M161 - AM Radio - Poor Reception

Date: 11/12/2019
Bulletin MAS002063
Section: Electrical Systems and
Devices

Figure 1. Left: fixing clip of the AM/FM1 Amplifier: left-hand side is plastic one (which is NOT OK), right-hand side is metallic one (which is OK). Right: detail of the metallic fixing clip.

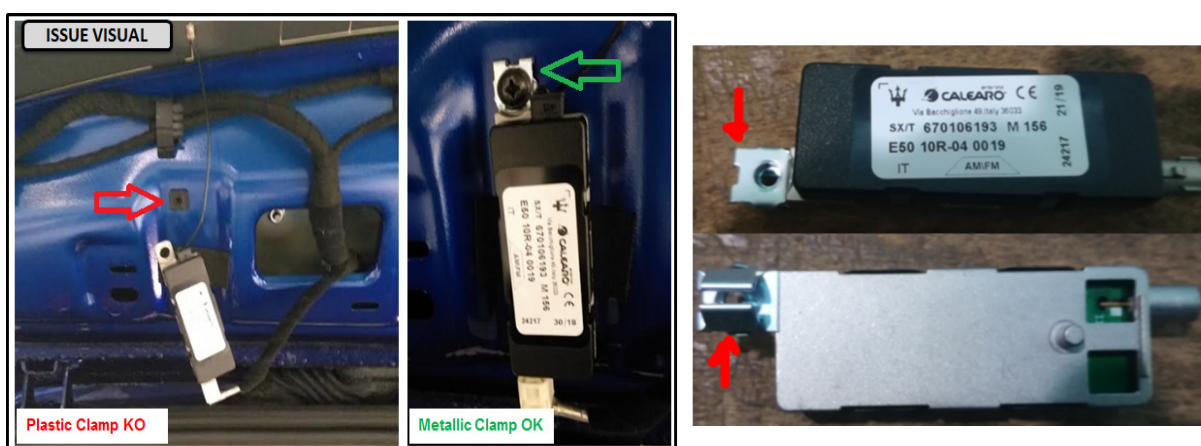
The problem could be caused by non-complaint fixing clip of the AM/FM1 Antenna Amplifier. If it is a plastic one, it might not give the proper ground to the Amplifier itself. The correct one is made of metallic material.

Inspect the AM/FM1 Antenna Amplifier as shown in Figure 1.

If the fixing clip is plastic one, DO NOT replace AM/FM Amplifier but proceed replacing only the plastic clip with metallic one (PN 673010856).
